100 MOhm-MOX-400-23 (all)

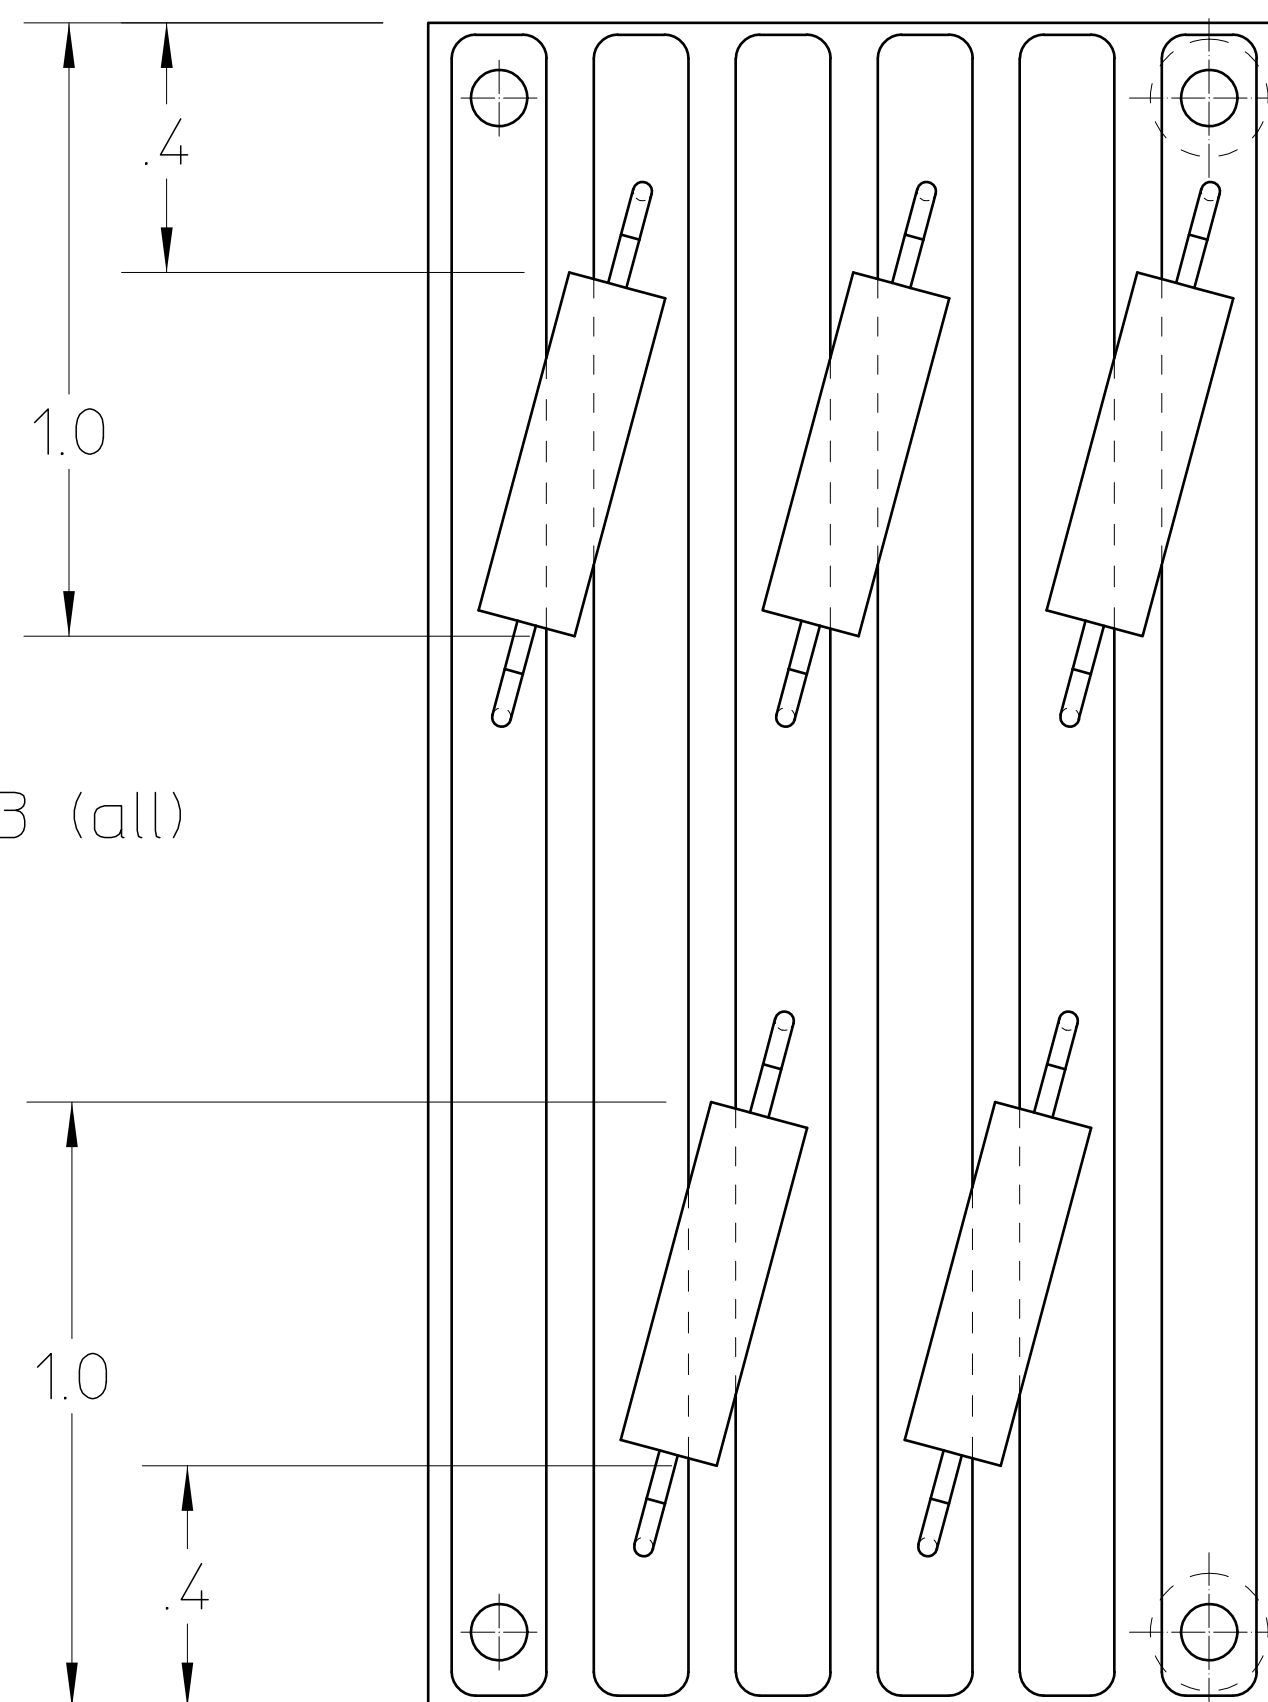
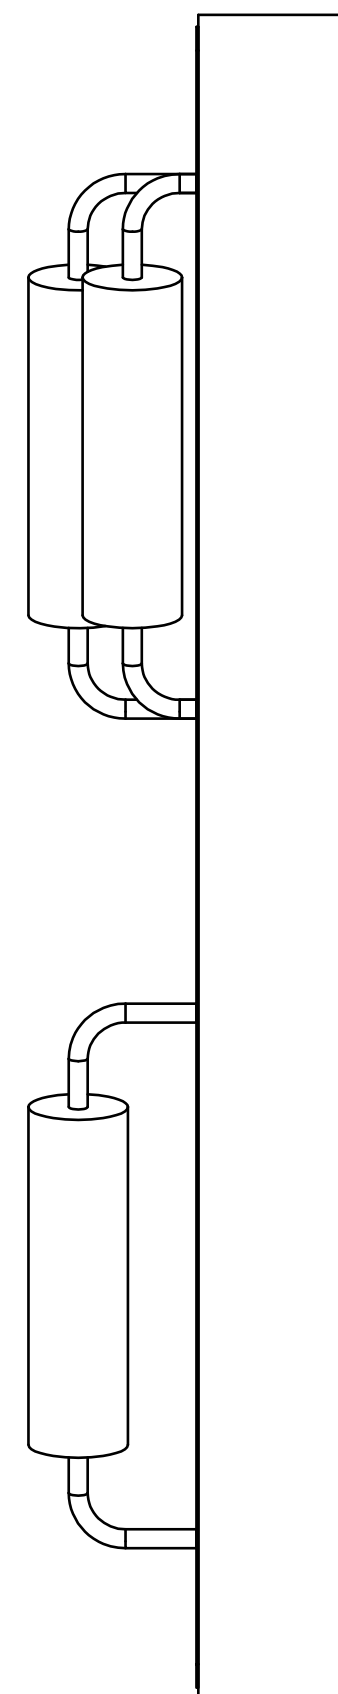
LEADS TO HAVE FLAT SECTION ADDED (.1"/.2" LG.) FOR PAD CONTACT
BEND LEADS CLOSER TO RESISTOR BODY TO PROVIDE FLAT SECTION
